Fuel Tank Bolts

Bulletin Type:	Safety Recall
Bulletin #(s):	19V-172 US 2019-126 CN
Job Code:	9901430
Flat Rate(s):	RC024 Inspect all bolts - .2 hour RC025 Replace bolts - .5 hour per tank 2 tanks on Seismic 1 tank on Talon

Publication Date:	March 2019
Make:	Jayco
Model(s):	Seismic Talon
Model Year:	2018

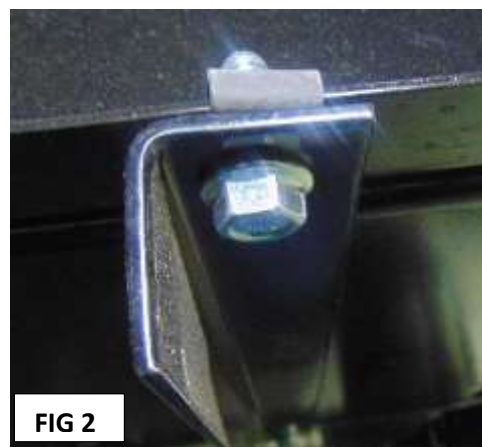
Inspect **each bolt** securing fuel tank support bracket (6 per tank) to confirm proper graded bolts with locking mechanism are present. Utilize the pictures below for your visual inspections.

Picture shown is an ungraded Hex Head Flange Bolt (no head markings)

– **NOT acceptable, must be removed and replaced**

Picture shown is a Grade 5 Hex Head Serrated Flange Bolt (3 lines on head)

– Acceptable, no rework required

Grade 5 Hex Head Bolt with flat washer

-Acceptable, with a lock washer, no rework required

-**Not acceptable, without lock washer, must be removed and replaced**

Hex Head Serrated Flange Bolt (Repair Fastener)

Tinnerman Nut – Replace when bolts are replaced

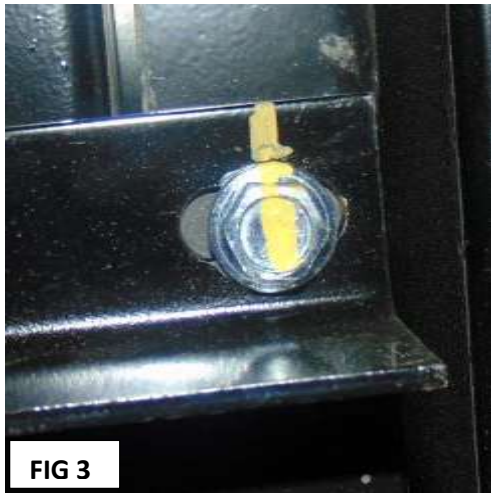
4. **FIG 1:** Place new Tinnerman 3/8-16 with 3/8" nut (0182038) from the kit on the cross member over the holes for the tank support bolts. Make sure the orientation is as shown in the photo.

5. Use the new hex head serrated flange bolt (3/8-16 x 1" GR 5 -0216363) from the kit.
6. **FIG 2:** Place the bolt through the hole in the tank support and start by hand into the tinnerman nut. Only snug the bolt up, do not completely tighten it at this point.

12. **FIG 3:** After torquing all tank support bolts, paint a yellow or white line on the edge of each bolt head, capturing the tank support. This step creates a visual indicator the bolt was properly torqued. It will also serve as a visual indicator to determine if a bolt has loosened in future inspection.
13. Repeat this procedure for supports when a second fuel tank exists (Seismic Only).

10. Repeat the same steps for the third tank support using new hardware, and snugging the 2 bolts up.
11. Start at one corner of the fuel tank. Using a torque wrench and the 9/16" socket, torque the tank support bolt at that location to **35 FT/LBS**. Torque the rest of the fuel tank support bolts to the same **35 FT/LBS**.
